# SC-FEC sublayer lane alignment process comments and remedies

In support of comments against IEEE 802.3ct D1.2

Comment #: 6, 11, 15, 17, 18, 19, 20, 21, 22, 23, 24, 25, 26, 27, 28, 29, 30, 31, 32, 34, 35, 36

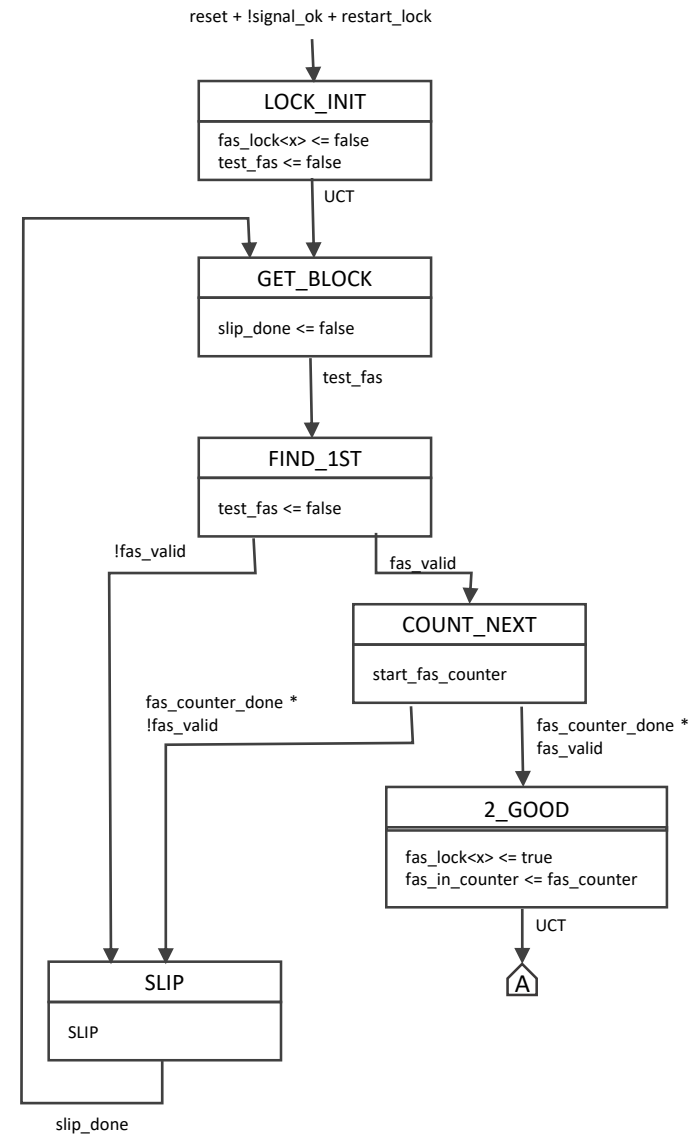
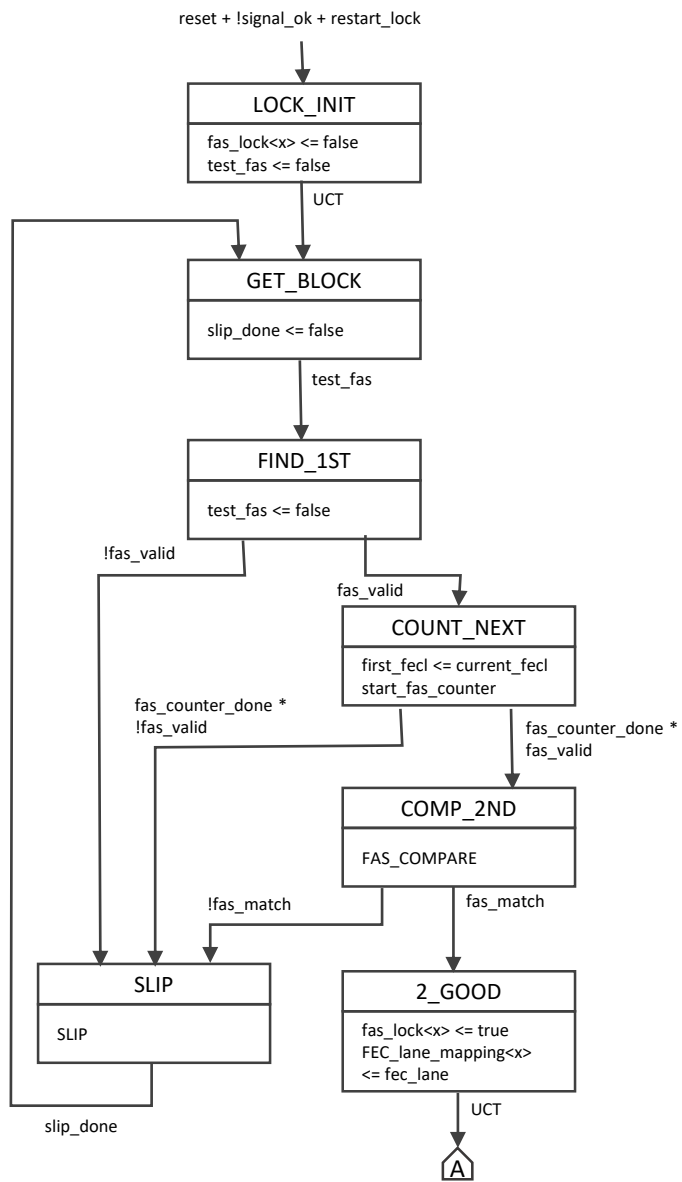
- Lane synchronization (comments: 15, 18, 21, 22, 23, 24, 25, 26, 27, 30):
  - Separate the lane identification from the lane synchronization process
  - Keep frame start location during re-synchronization
  - Changes:
    - Update the synchronization and synchronization loss state diagrams and related variables and counters
    - New lane identification state diagram and related variables and counters
- Deskew (comments: 19, 31, 32):
  - Fix deskew state diagram
    - Update the state diagram and related variables
- SIGNAL\_OK indication (comments: 11, 17, 20, 28, 29):
  - Add stability counter
    - New fec\_align\_indication state diagram and related variables and counters
- Related changes to clause 153.2.3.3.1 and MDIO (comments: 6, 34, 35, 36)

# SC-FEC synchronization state diagram (1) - Change

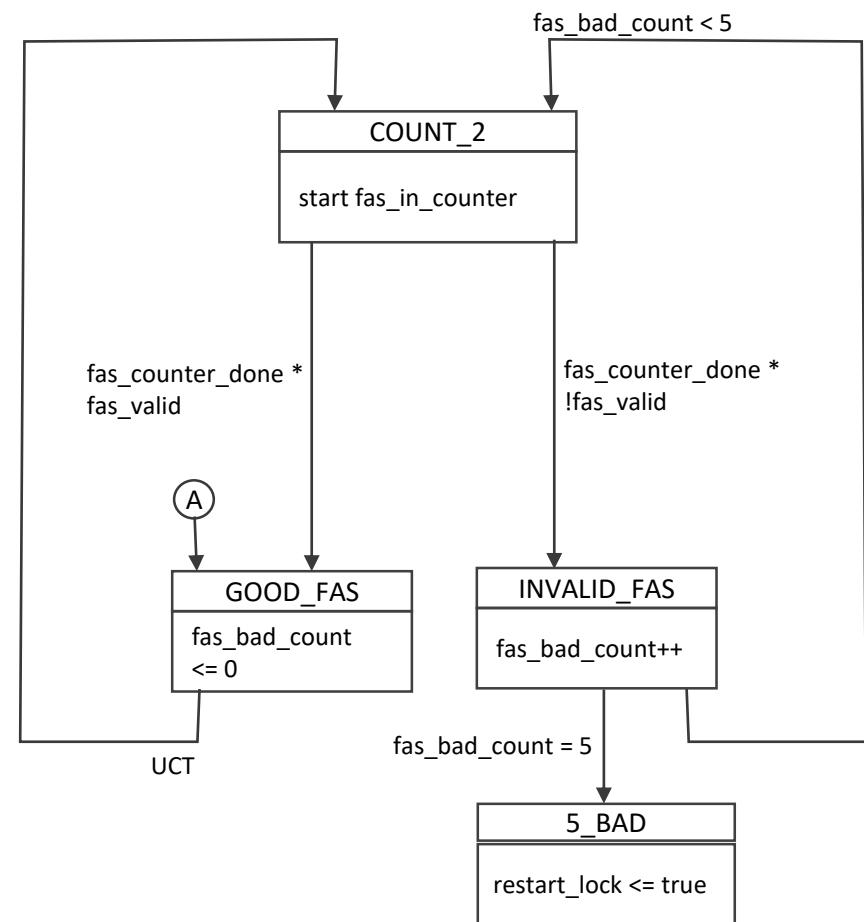
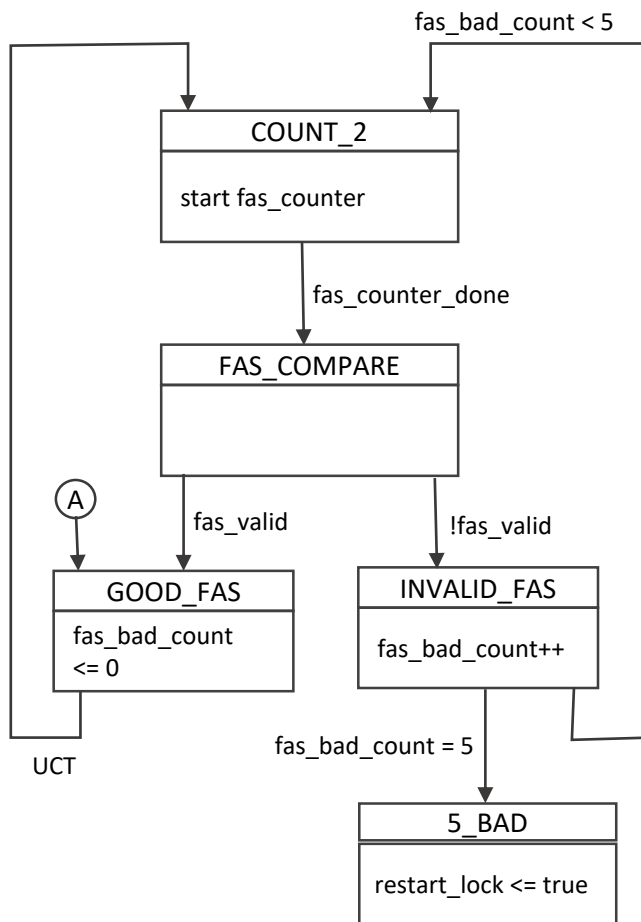
- Synchronization (1):
  - Lane identification variables set removed from states COUNT\_NEXT and 2\_GOOD.
  - COMP\_2ND state removed to simplify the state machine since the FAS\_COMPARE function is not required now.
  - fas\_in\_counter used by the SC-FEC synchronization loss detection state machine is set to the fas\_counter value only once a new FAS location is identified.
- Synchronization loss (2):
  - FAS\_COMPARE state removed to simplify the state machine since the FAS\_COMPARE function is not required now.
  - Use fas\_in\_counter instead of fas\_counter, so that during a re-synchronization the FAS location is retained until a new FAS location is identified by the synchronization state machine.
  - Note that if the synchronization loss was due to BER, the new FAS location will be equal to the previous one.

# Lane identification state diagram - New

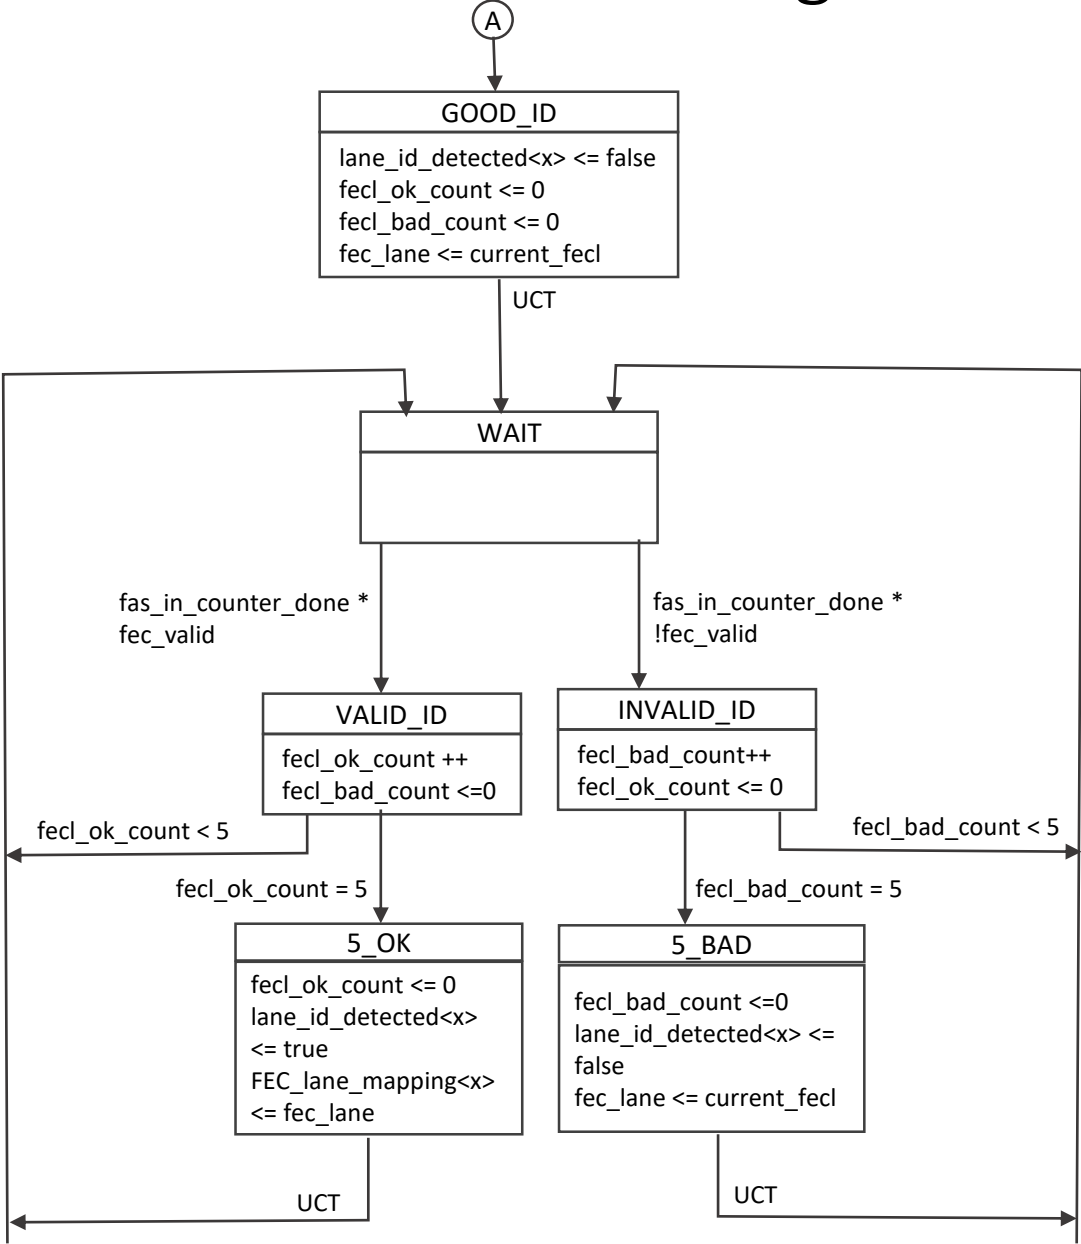
- Start only after synchronization acquired.
- New lane\_id\_detected<x> x=0:19 variable added
  - Added also as an input to MDIO
- New Lane ID accepted if the same Lane ID value is detected 5 frames in a row.
  - New value written to FEC\_lane\_mapping<x> for the deskew state machine and the MDIO.
  - Correspondent lane\_id\_detected<x> set to “TRUE”.
- If a different value than the accepted Lane ID value is detected 5 frames in a row.
  - Test new value for acceptance.
  - Correspondent lane\_id\_detected<x> set to “FALSE”.
- The accepted Lane ID is retained until a new Lane ID is detected.
- Note that if the Lane ID loss was due to BER, the new Lane ID will be equal to the previous one.

# SC-FEC deskew state diagram - Change

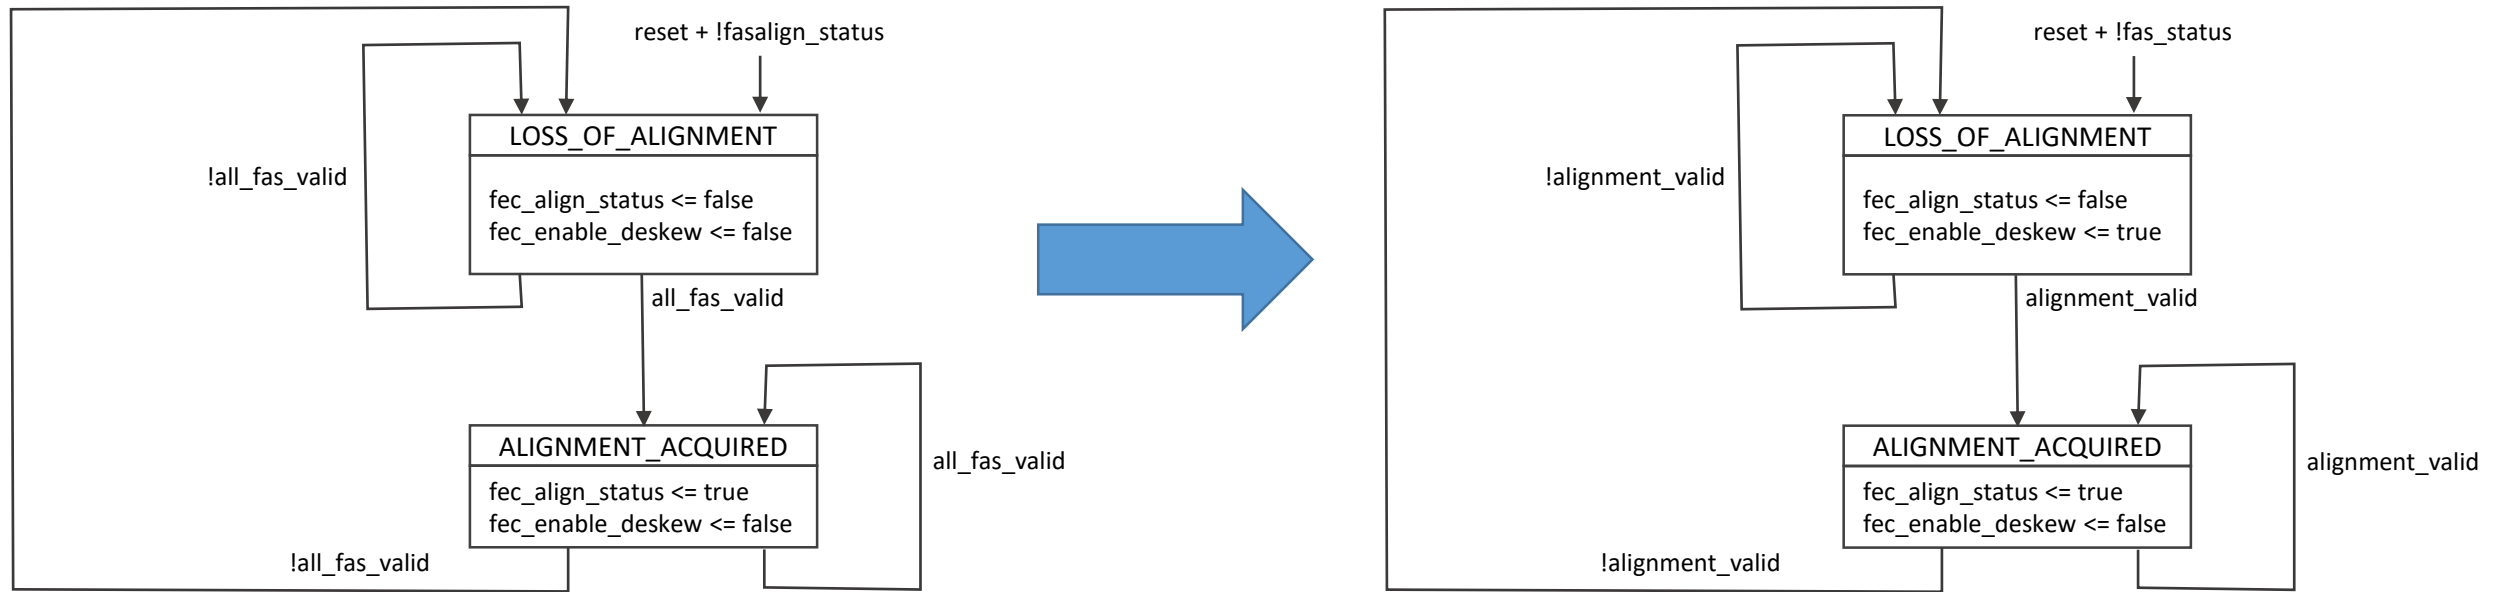
- Replace `all_fas_valid` (not defined) with `alignment_valid`.
- Replace `fasalign_status` (not defined) with `fas_status`.
- Set `fec_enable_deskew` to “TRUE” in the `LOSS_OF_ALIGNMENT` state to start deskew process.
- Note that these changes make the Deskew state diagram similar to Figure 82–14: PCS deskew state diagram.
- Define `fec_enable_deskew` in a similar way as defined in clause 91.5.4.2.1, but do not allow bits to be discarded during the deskew process.
  - The deskew process may be frequently started due to high pre-FEC BER, if we allow discarding bits during the process communication will be impaired.

# SIGNAL\_OK monitor state diagram - New

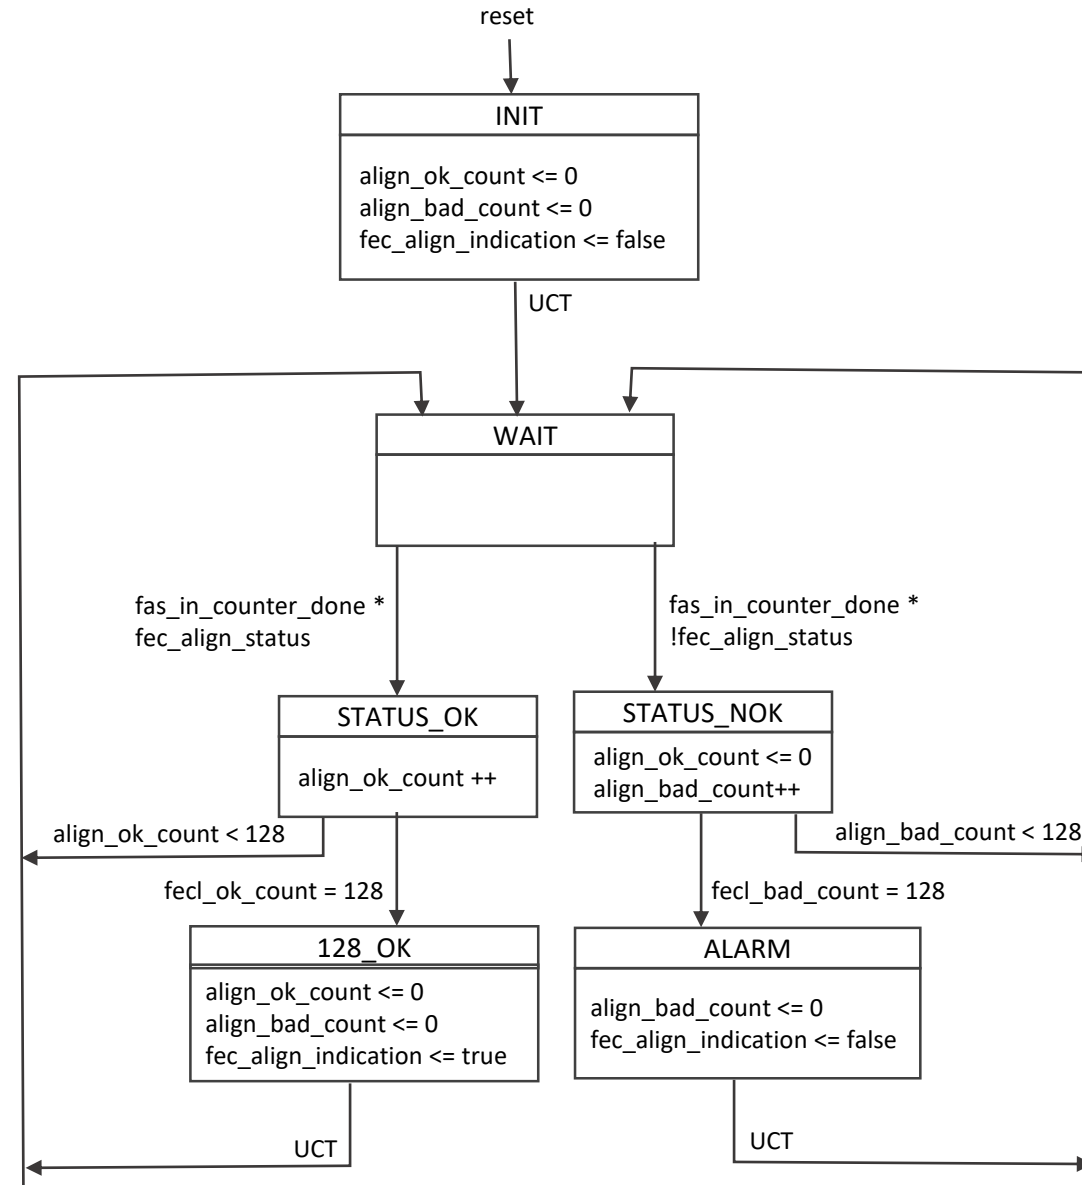
- State machine runs continuously and monitors fec\_align\_status.
- New fec\_align\_indication variable defined to contain the “debounced” fec\_align\_status value.
  - fec\_align\_indication drives the SIGNAL\_OK parameter
- fec\_align\_indication is set to “TRUE” when align\_ok\_count reaches 128 and to “FALSE” when align\_bad\_count reaches 128.
- align\_ok\_count cleared each time a loss of alignment is detected.
- align\_bad\_count cleared only if align\_ok\_count reaches 128.
- The scheme provides for intermittent losses and is similar to the scheme defined in ITU-T G.798.
  - Note that ITU-T G.798 defines a 3 msec integration time per lane, while the proposed scheme is one process for the whole signal.
